#### 3.1 10 Markham Avenue ASHBURTON (also known as 2-18 Markham Avenue)

<b>Application no.:</b>	<b>Planning Scheme Amendment C321boro</b>
<b>Responsible director:</b>	<b>Shiran Wickramasinghe City Planning</b>
<b>Authorised by:</b>	<b>Simon Mitchell, Manager Statutory Planning</b>
<b>Report officer:</b>	<b>Seuna Byrne Principal Planner - Statutory Planning</b>

## STATUTORY PLANNING OFFICERS' REPORT

**Above: To-scale dimensions of the width of the southern facades of Buildings C and E, extracted from the Building Envelope Plan in the Incorporated Document**

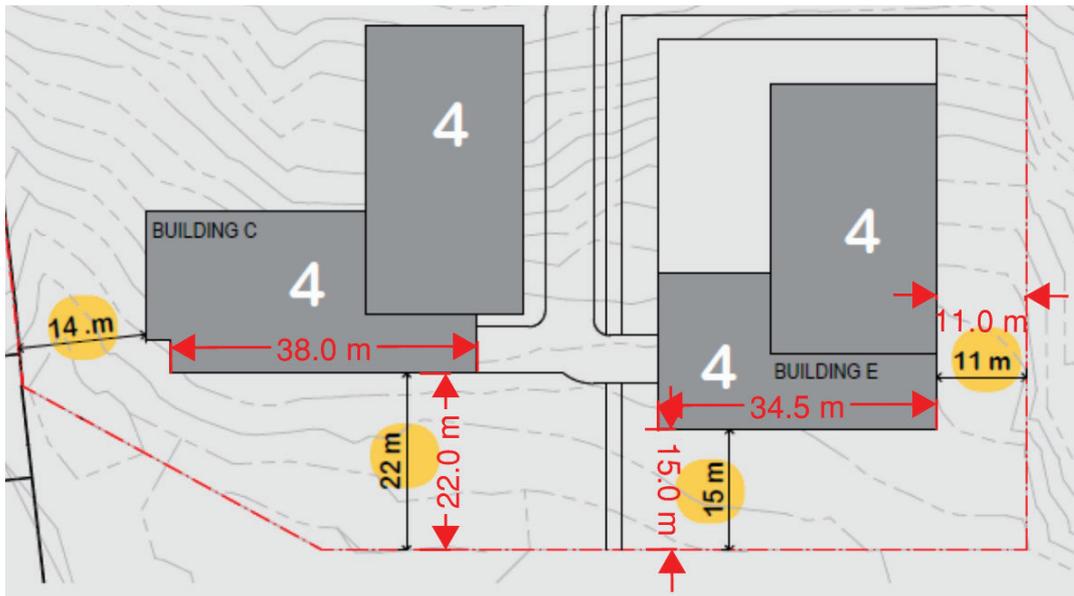
Assuming a 4-storey building has a maximum overall building height equivalent to 15.0m (on a sloping site, such as this), Rescode Standard B17 would recommend a minimum setback of 10.09m from the southern boundary. The proposed setbacks exceed the minimum recommended by Standard B17. However, the breadth of the buildings is of concern. Officers have scaled the width of Buildings C and E on the Building Envelope Plan and found them to be in the order of 38.0m and 34.5m wide, respectively.

The Building Envelope Plan permits the southern façade to have a flat and sheer 4-storey alignment. There are no buildings in the local area which provide context for the scale and breadth of proposed buildings. Nor is there any strategic imperative to depart from the existing domestic residential scale or rhythm of building spacing around the perimeter of the site. Notwithstanding the proposed setbacks from the southern boundary, and as a consequence of the uncertainty in relation to the location of trees to be retained that might otherwise filter views of the buildings from Markham Reserve, it is recommended the Incorporated Document be amended to include a condition requiring the southern façades of Buildings C and E to be articulated vertically and horizontally, to meet the provisions of Clause 12. Officers envisage this should involve the creation of recesses in the building alignment, together with articulation and visual interest through the application of varied materials and finishes.

**Above: To-scale dimension of the width of the southern facades of Buildings A, B and D, extracted from the Building Envelope Plan in the Incorporated Document**

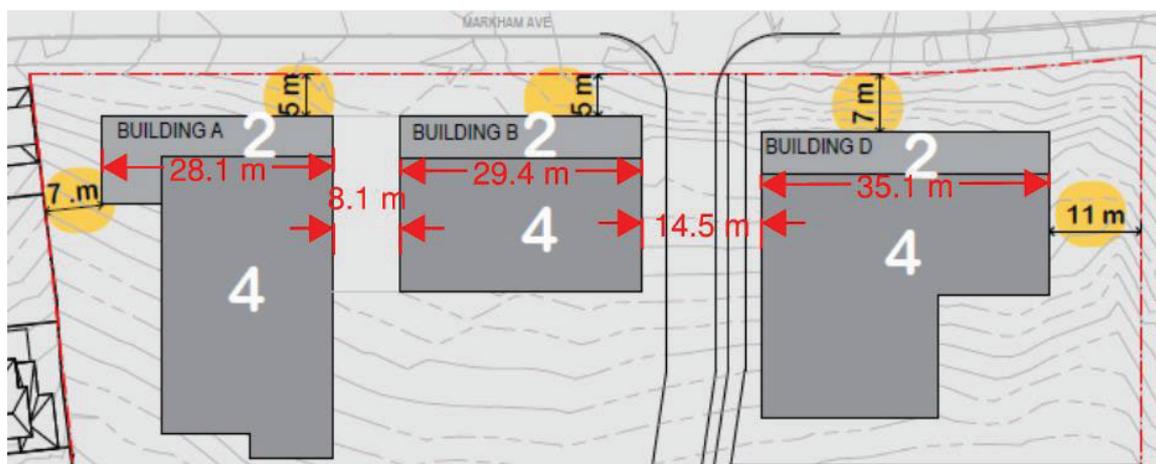
As is already illuminated in this report, officers are of the view the proposal fails to respond appropriately to the Gardiners Creek environs, due to the height and breadth of Buildings C and E, their sheer facades and inadequate information in relation to tree retention/removal and replacement tree planting within the southern boundary setback. Officers also hold concerns with the height and siting of Buildings A, C, D and E, due to the shadows they will cast over the public and private realm.

The concept of locating buildings campus-style throughout the site is supported by officers, as it creates site permeability. The Building Envelope Plan proposes three 2-storey buildings facing Markham Avenue, which rise in height to 4-storeys at their rear. Officers were advised by DHHS that the 4-storey form at the rear of Buildings A, B and

D in-part utilise the fall of the land to achieve their height. This is also supported by officers, as it is consistent with the 2-storey scale of buildings in Markham Avenue. Although the Building Envelope Plan shows Buildings A, B and D also have wide front facades (in the order of between 28m-35m wide) any concerns that officers might have with visual bulk are addressed by Condition 4.2.6, which requires:

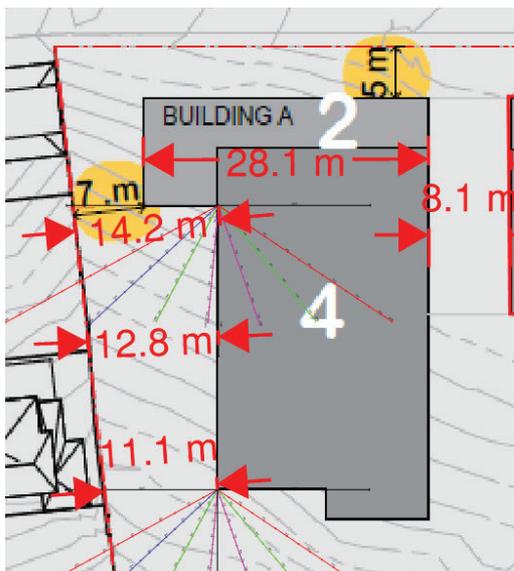
Buildings A and C are located proximate to the western boundary interface with the rear yards of homes in Ashburn Grove. The 4-storey components of the proposed buildings are set back approximately 11.1m and 14m from the west, respectively. Officers are critical of the lack of dimensioned setbacks on the Incorporated Document Building Envelope Plan. The setback of 11.1m from the south-west corner of Building A to the western boundary has been scaled by officers and is an estimate (notwithstanding the Incorporated Document says the future development only needs to be *"generally in accordance with"* the building envelope). If the estimated dimension of the setback is accurate, and if the height of the building does not exceed 15.0m, and if the development is built in accordance with the Building Envelope Plan, the setback exceeds the minimum 10.09m required by Standard B17. Further north, the setback of the 4-storey section of the building increases to a maximum of 14.2m (scaled), some 4.11m more than the minimum required by Rescode.

It is vital the setback areas to the west of Buildings A and C are kept at natural ground level and used for deep-soil canopy tree planting. There does not appear to be any significant trees located in this part of the subject site suitable for retention, however there are a number of trees within the neighbouring properties (such as at Nos. 91, 95,

97 and 99 Ashburn Grove) which require protection during construction. Officers recommend the Incorporated Document be amended to expressly require advanced canopy tree planting (minimum 3.0m when planted) within the western boundary setbacks of Buildings A and C, incorporating species that will attain a height of at least 15m at maturity. This will assist with filtering views of the development.

**Above: Extract from the endorsed ground floor plan of 93A Ashburn Grove (See PP10/00298 and Post12/00968, endorsed by Council on 19 December 2012)**

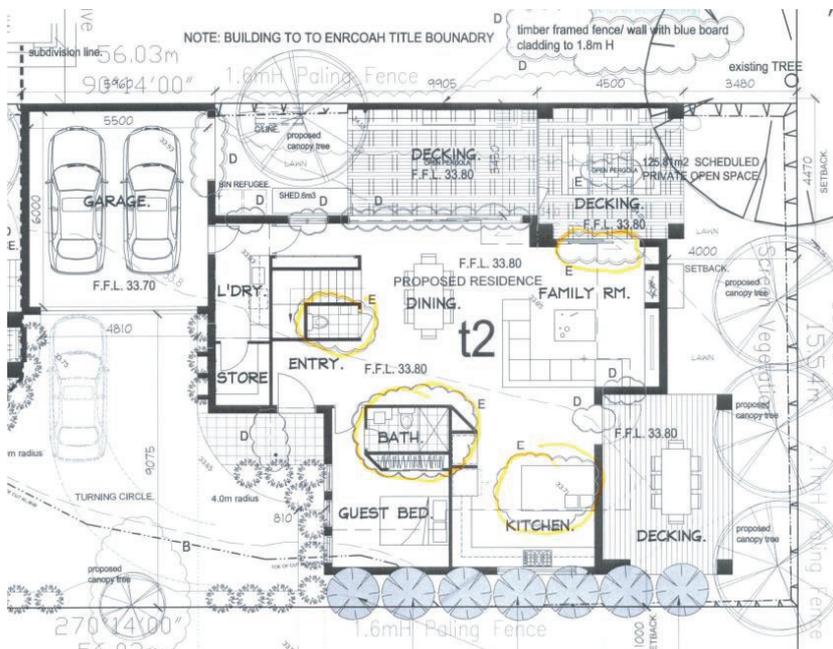
Due to its size, configuration and orientation, the secluded private open space of No. 93A Ashburn Grove does not currently receive sunlight to *“at least 75%, or 40sqm with minimum dimensions of 3m, whichever is the lesser...”* for *“a minimum of five hours of sunlight between 9am and 3pm on 22 September.”* Therefore, the Standard says the amount of sunlight it receives should not be further reduced.

**Above: Overshadowing analysis prepared by Council officers using Bluebeam Revue software, depicting the extent and duration of shadows cast by (presumed) 15m high, 4-storey Building A at 9am (red) and 10am (blue) on 22 September**

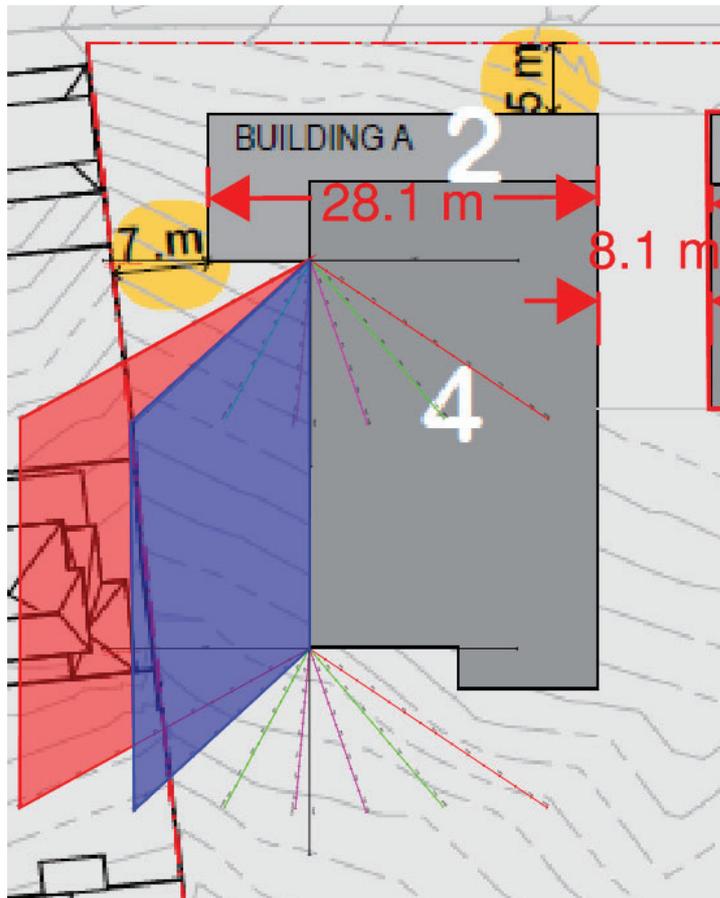
Officers have prepared their own shadow analysis (above) which confirms the development (if it attains an external wall height of 15m) will cast shadows over the secluded private open space of No. 93A Ashburn Grove at 9am and 10am on 22 September, reducing its already limited solar access. This means the proposal in its current form will not comply with Standard B21 and is considered to be unreasonable. Officers note it appears the height of the north-south aligned section of Building A would need to be reduced to a maximum of 10m (approximately 2-storeys on a sloping site) to ensure the extent of shadows cast by the development does not exceed those cast by the existing boundary fence. Alternatively, the setback of the building from the western boundary should be increased, or a combination of height reductions and setback increases. As with the DHHS assessment of the Rescode site coverage standard which was found to be inaccurate.

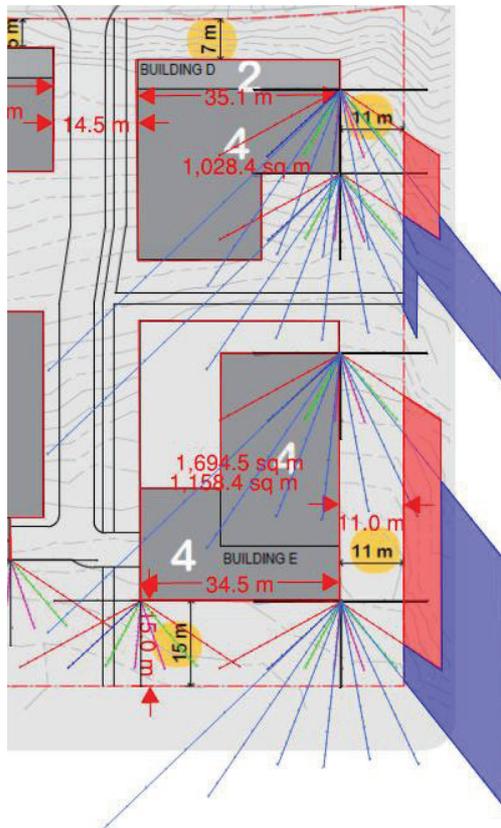
This assessment undertaken by officers is unreasonably hindered by the lack of shadow diagrams in the Amendment documents. Officers have used Bluebeam Revue software to plot the extent of shadows cast by Buildings D and E at the September Equinox.

These demonstrate the 4-storey section of Building D<sup>27</sup> will cast shadows over part of the children's playground soon after 2pm. The extent of shadows appears to extend beyond the shadows cast by the pavilion building itself (i.e. there would be a net increase in the extent and duration of shadows cast over the children's playground). It is important to protect the amenity of this shared resource, particularly in circumstances where demand for its use is likely to increase as a direct result of the introduction of an additional 178 households next door. Due to the setbacks and predominantly east-west orientation of Building D, it is likely only modest modifications to the height or setback of the fourth floor would be required to address this issue.
